Limerick Generating Station, Unit 1  
Renewed Facility Operating License No. NPF-39  
NRC Docket No. 50-352

Subject: Submittal of Analytical Evaluation of Core Spray Injection Nozzle-to-Safe End Weld (N5A)

**Evaluation of Unit 1 DCA-319-1 N5A Flaw Identified in IR 04332524**

Subject: Independent review of encoded ultrasonic examination data from dissimilar metal weld DCA-319-1 (N5A) at Unit 1 of the Limerick Generating Station

*Figure 1  
Polar views showing location of reported embedded flaw in the N5A DMWV (2008 examination data on left, 2020 on right)*

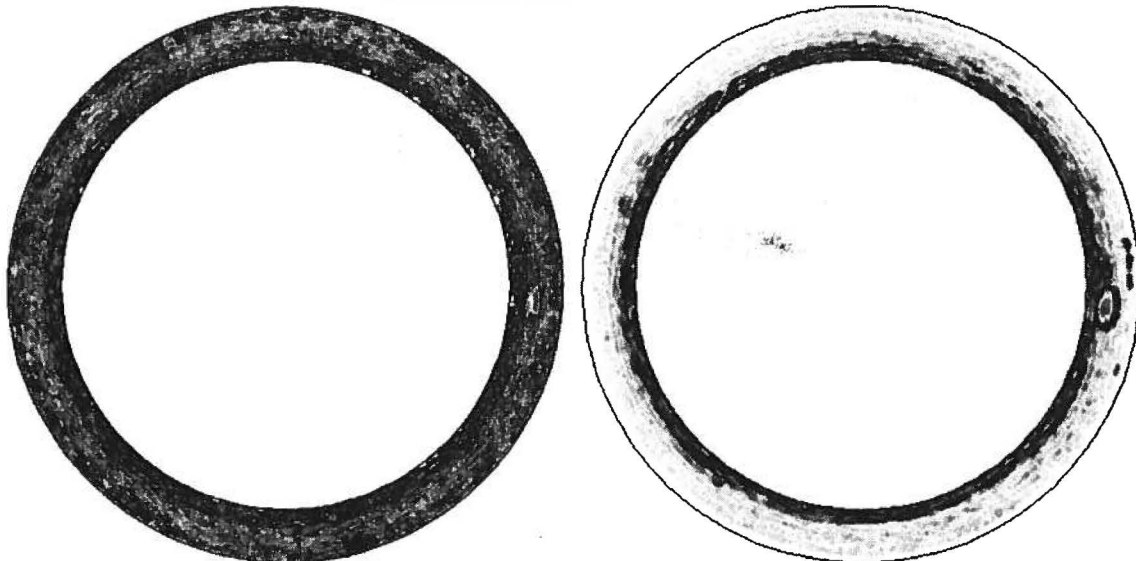
EPRI NDE Center staff performed an independent review of the supplied automated phased array examination data from dissimilar metal weld DCA-319-1 (N5A) at unit 1 of the Limerick Generating Station. The review was performed after Exelon's inspection vendor, GE Hitachi Nuclear Energy Americas (GEH), reported an embedded weld fabrication flaw. Examination data from the previous 2008 and current 2020 examinations were provided to EPRI. The location of the reported indication can be seen in the 2008 (left) and 2020 (right) UT polar views at the approximate 90° positions shown in Figure 1.

Figure 2  
45°RL B-scan presentation (side view) showing location of the reported embedded flaw (2008 examination data on top, 2020 on bottom)

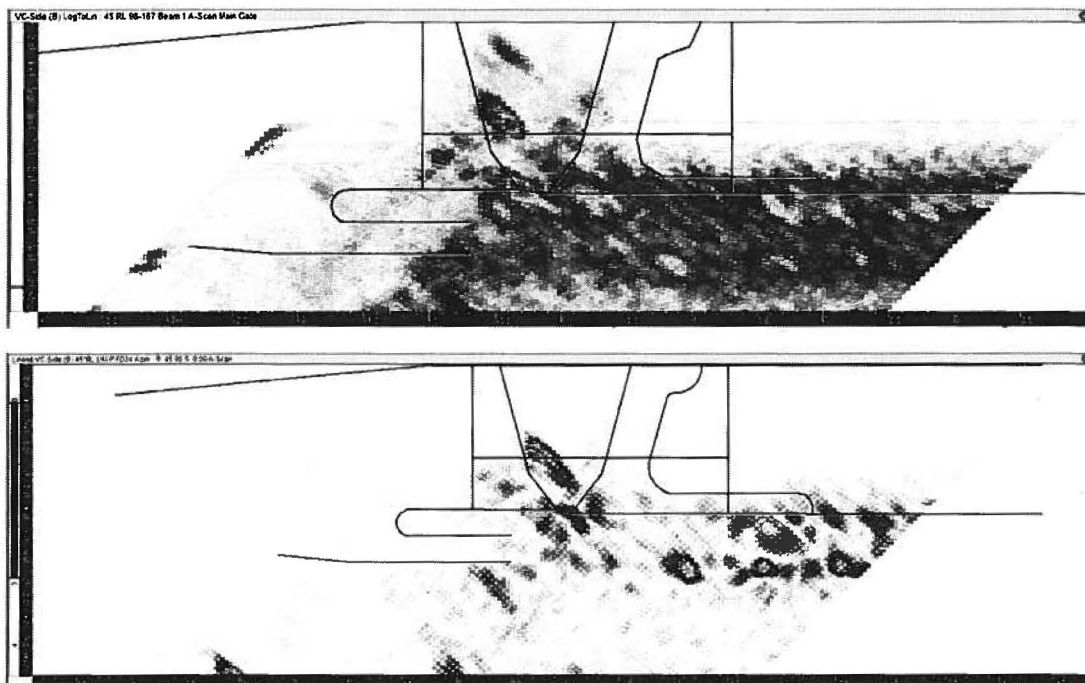
The reported flaw was located near the safe-end side weld fusion line and is positioned along the upper boundary of the ASME Code[1] inner one-third examination volume. Figure 2 shows the side-view image of the ultrasonic response using the 45°RL examination data during both the 2008 (top) and 2020 (bottom) examinations. The focal law used to generate the 45°RL examination angle during the 2020 examination is intended to interrogate the inside surface of the component by electronically focusing the ultrasonic energy at 1.3" [34mm] of material depth. This electronic focal depth corresponds to the inside surface of the DMW. If the reported flaw were attributed to an inside surface connected flaw, it is expected that the examination data would exhibit a "corner trap" response linking the reported ultrasonic indication to the inside surface; however, no such response is present.

Figure 3  
60°RL B-scan presentation (side view) of showing location of the reported embedded flaw (2008 examination data on top, 2020 on bottom)

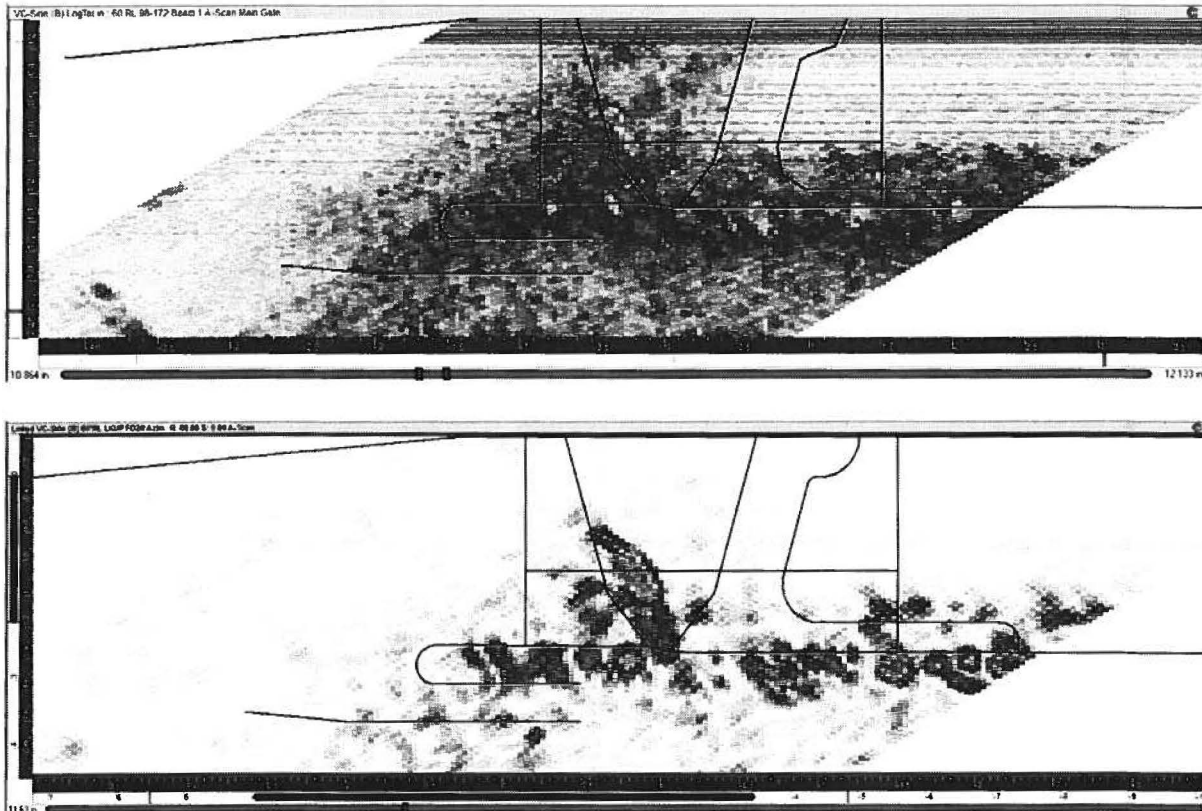
Figure 3 shows the side view image of the ultrasonic response obtained from the 60°RL examination angle during the 2008 examination (top) and 2020 examination (bottom). The focal law used to generate the 60°RL examination angle during the 2020 examination is intended to interrogate a thickness region that is approximately 0.79" [20mm] below the outside surface of the component. This focal depth corresponds to the depth location of the reported flaw. The 60°RL examination data also displays an embedded ultrasonic indication located along the upper boundary of the ASME Code examination volume.

Figure 4  
0° B-scan presentation (side view) showing location of reported flaw within the weld material (2020 examination)

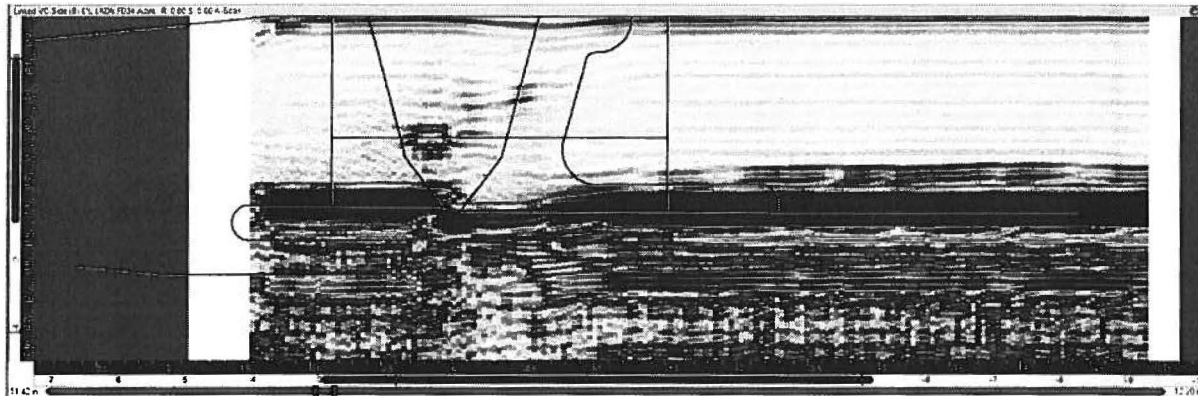
The reported flaw indication was also detected at the same location using the 0° examination data (see Figure 4). 0° examination angles are well suited for detection of weld fabrication flaws. Since these examination angles are not well suited for detection of inside surface connected SCC flaws, the ability to readily identify the reported flaw with the 0° examination angle provides additional evidence that it is attributed to a weld fabrication related reflector.

Figure 5  
C-Scan (plan view) presentation showing location of reported embedded flaw (2008 examination data on top, 2020 on bottom)

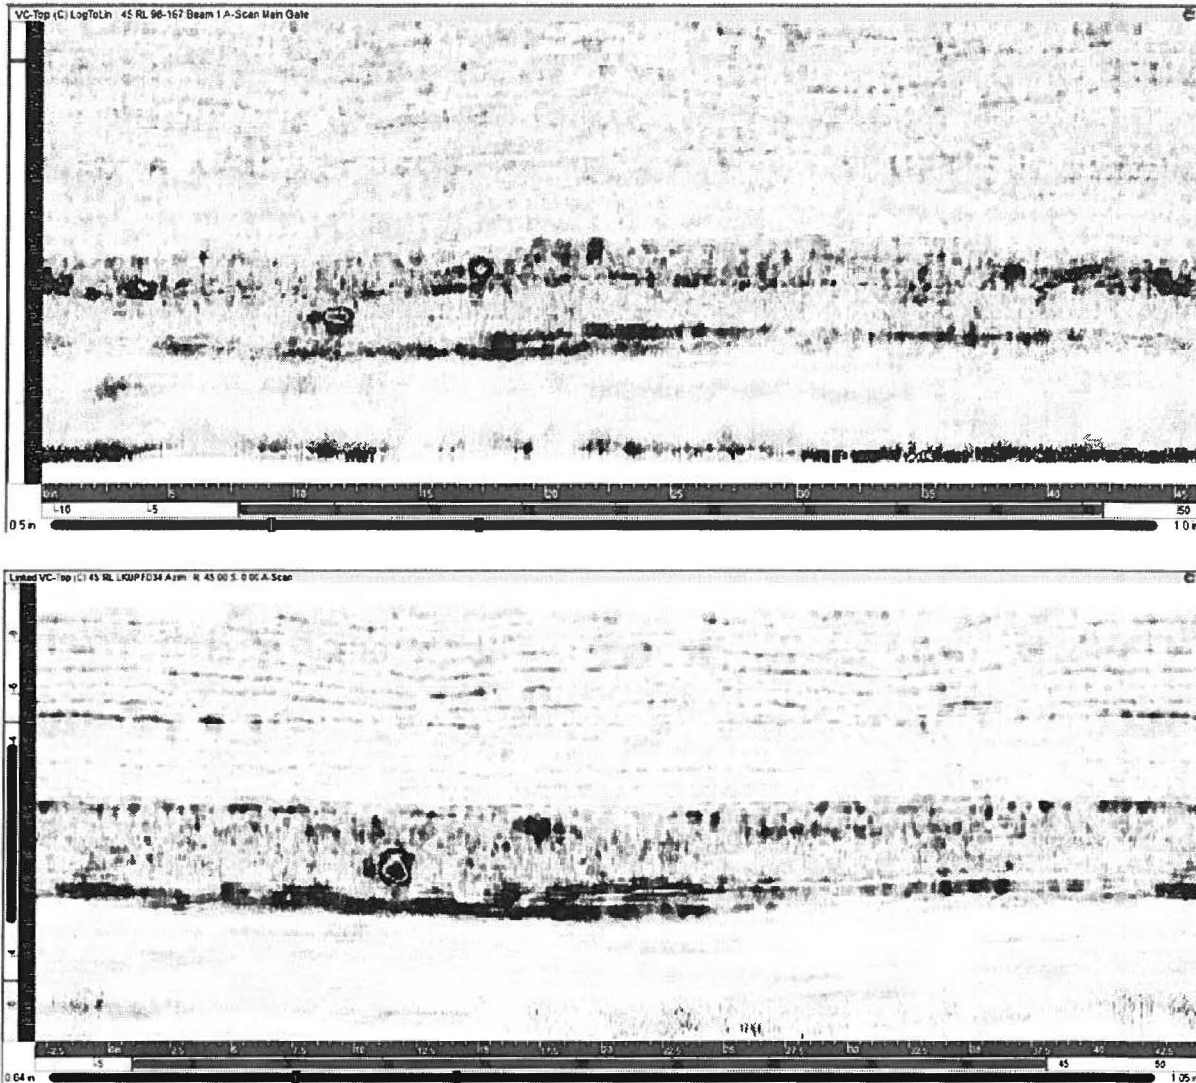
Figure 5 shows the C-scan (roll-out view) presentation, which is the same presentation that would be represented by a radiograph. The 2008 examination data is shown in the top image while the 2020 examination data is shown in the bottom image. The horizontal axis represented by the green index rulers located along the bottoms of these images correspond to the circumferential axis of the component. The vertical axis represented by the blue scan rulers along the left edges represent the longitudinal axis of the nozzle. The inside-surface layer of parallel clad beads on the nozzle side are visible along the upper portion of the images while the safe-end side of the weld joint is shown on the lower portion of the images. The location of the weld is displayed as the area of slightly increased amplitude (e.g. pattern of darker blue responses) that extends for the complete 360° circumference of the roll-out views. The reported embedded flaw is clearly evident in each image as the high-amplitude (i.e. red) response located within the safe-end side of the visible weld pattern.
